PCN Number:	20160426000	PCN Date:	6/9/2016
Title:	Datasheet for MSP430FR5738		
Customer Contact:	PCN Manager	Dept:	Quality Services
Change Type:			
<input type="checkbox"/>	Assembly Site	<input type="checkbox"/>	Design
<input type="checkbox"/>	Assembly Process	<input checked="" type="checkbox"/>	Data Sheet
<input type="checkbox"/>	Assembly Materials	<input type="checkbox"/>	Part number change
<input type="checkbox"/>	Mechanical Specification	<input type="checkbox"/>	Test Site
<input type="checkbox"/>	Packing/Shipping/Labeling	<input type="checkbox"/>	Test Process
<input type="checkbox"/>		<input type="checkbox"/>	Wafer Bump Site
<input type="checkbox"/>		<input type="checkbox"/>	Wafer Bump Material
<input type="checkbox"/>		<input type="checkbox"/>	Wafer Bump Process
<input type="checkbox"/>		<input type="checkbox"/>	Wafer Fab Site
<input type="checkbox"/>		<input type="checkbox"/>	Wafer Fab Materials

Beyond other datasheet changes, the important change to note is the change in the drawing of the DSBGA:

Top View of Package: Sympo Change

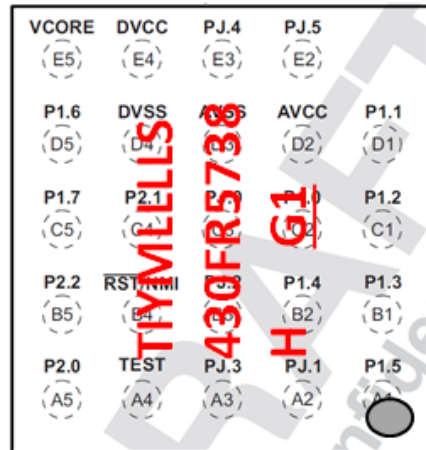
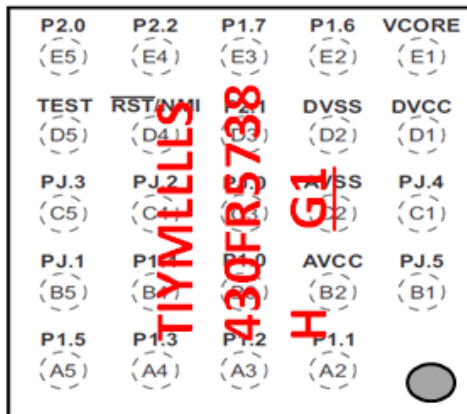
Datasheet Update: Drawing is rotated by 90DEG and ball numbers are adjusted

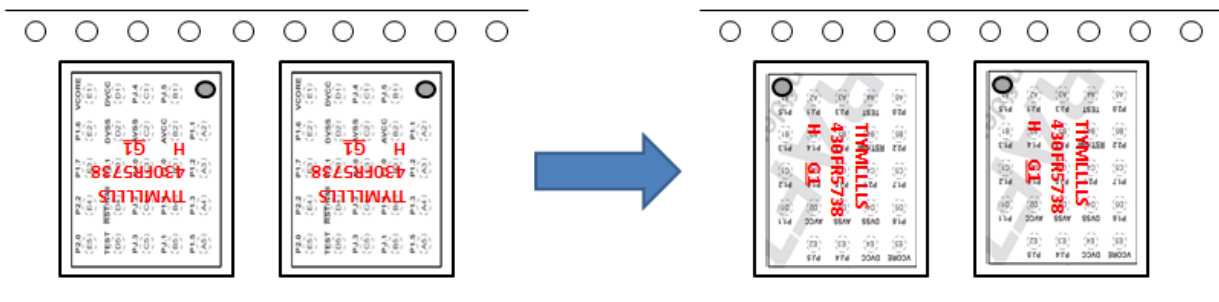
Tape and Reel needs to change: Device rotated 180DEG in Pocket

NOTE: Requirement: Pin1 (A1) Marker needs to be at punch row side
